BOARD OF ZONING APPEALS STAFF REPORT

Agenda Item: BZA 25-007

Application Type: Developmental Standards Variance

Summary: Applicant is seeking a Developmental Standards Variance from TABLE 26-6. 701. B. WALL SIGN SPECIFIC STANDARDS, DIMENSIONS, SIGN SIZE, and ADDITIONAL STANDARDS to install a new MUNSTER HIGH SCHOOL PERFORMING ARTS CENTER sign to exceed the permitted height and over an architectural details.

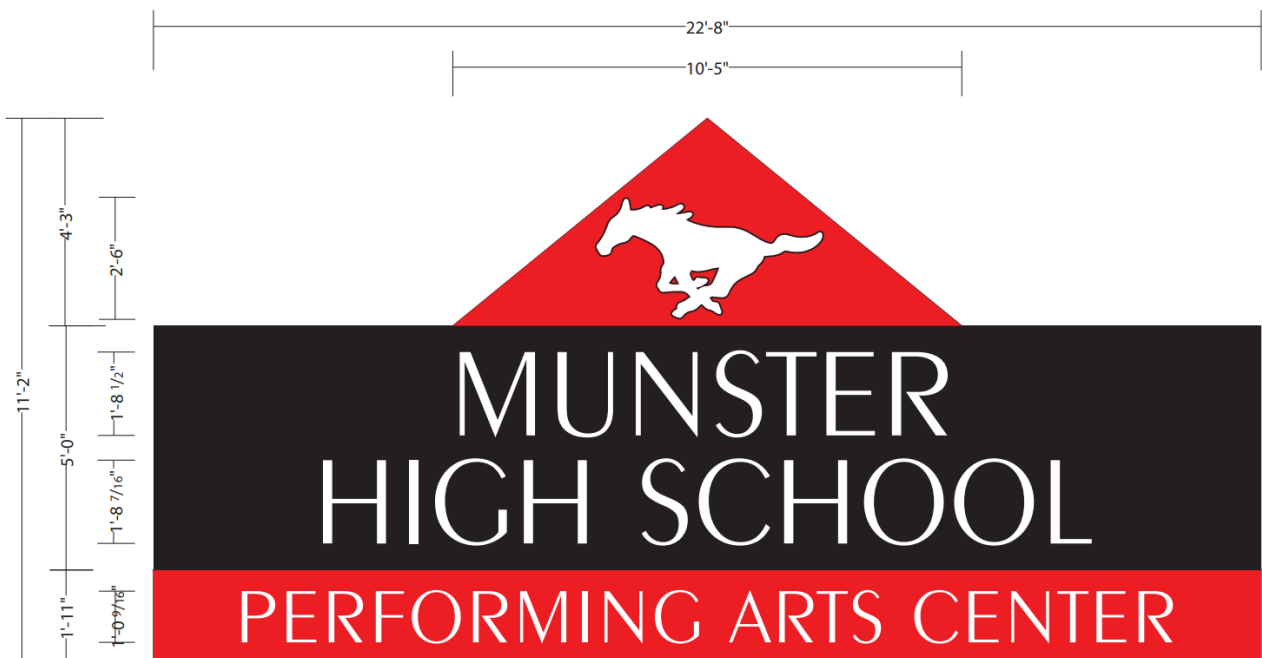
The applicant is requesting to install an internally illuminated, 11'-2" High by 22'-8" Wide routed face wall sign with $\frac{3}{4}$ " white acrylic push through letters, and $\frac{1}{2}$ " non-illuminated flat cut-out logo over the following architecture elements of the building:

- Triangular limestone pediment over entry.
- Exposed I-Beams framing around the entry.

Staff finds all documents are in order to conduct a public hearing. Staff also finds that while the proposed sign and aluminum wrap and backer panels may not be directly injurious to the public health, safety, morals, and general welfare of the community; Staff finds the follow two conditions would be adversely impacted:

- The proposed sign would adversely affect Munster High School's mid-20th-century (1966) institutional/functional architectural design. Architectural elements incorporated into the building which characterized the institutional architecture design are the aesthetic and symbolic materials of strength and learning are the triangular limestone over the entrance and exposed robust I-Beams framing the entrance. At a pedestrian level, the aluminum wrap and backer panel for a sign would cover two significant architectural and exposing only a beige/tan brick.
- The strict applications of the terms of the zoning ordinance will not result in difficulties in the use of the property because sign lettering and branding may be installed without the need to cover architectural elements of the building and utilizing font consistency and brand iconography applied to other building entrances.

Staff Recommendation: Review Conditions of Approval Questions
Review of Zoning Code(s)
Deny and redesign sign to compliment the building architecture.

Staff also recommends that the applicant consult with an architect to recommend design sign standards which will help build brand identity and enhance the mission of institutional architecture and the complementary additions to the school campus that have occurred over the years. Finally, staff would encourage the school to install wayfinding signage throughout the site to support a campus environment and less commercial visibility sign efforts from a public right-of-way.
